Groundwater Transfer Review Summary Form

Transfer/PA # T- 14370

Application: T-14370

Applicant Name: Bend Golf and Country Club

Hydrograph 1: Water level elevations of the applicant's wells and adjacent observation wells.

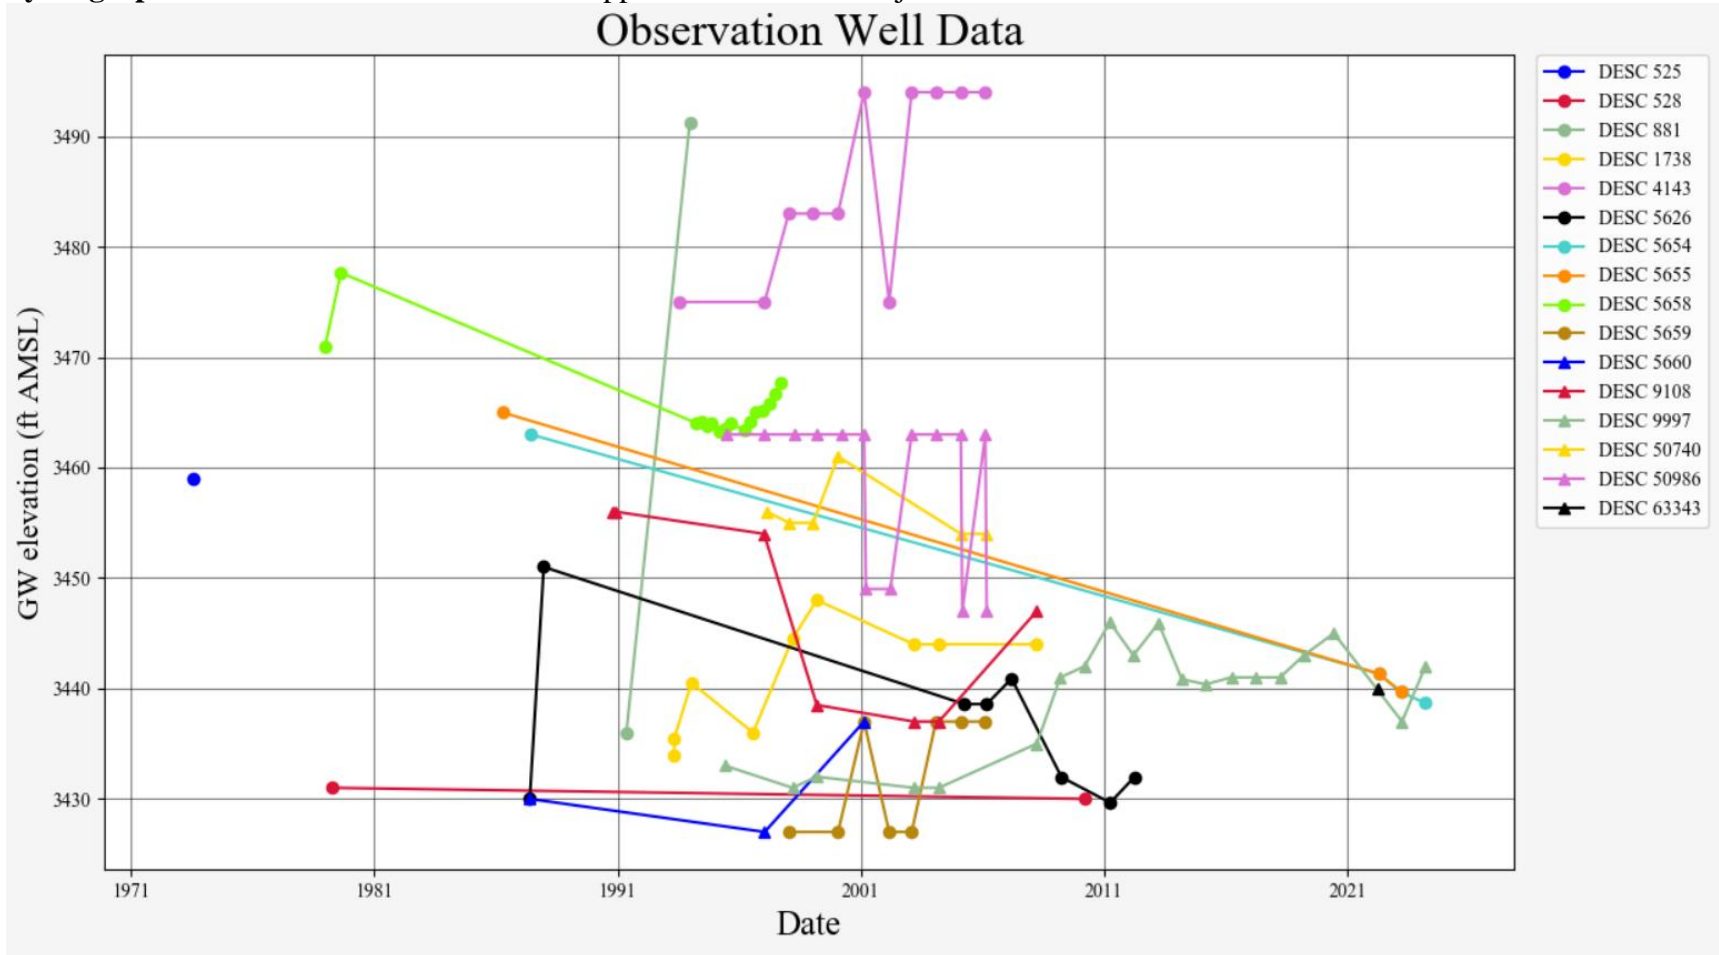
2. Will the proposed POA develop the same aquifer (source) as the existing authorized POA?
 Yes No Comments: DESC 525 is 377 feet deep and accesses the Deschutes aquifer hosted within lavas from the Cascade Range. DESC 63343 is immediately adjacent to DESC 525 and drilled to a depth of 490 feet. Both have similar water level elevations. Water level data from wells in the area fall range from 3430-3490 feet AMSL, which is commensurate with groundwater contours published by the USGS.
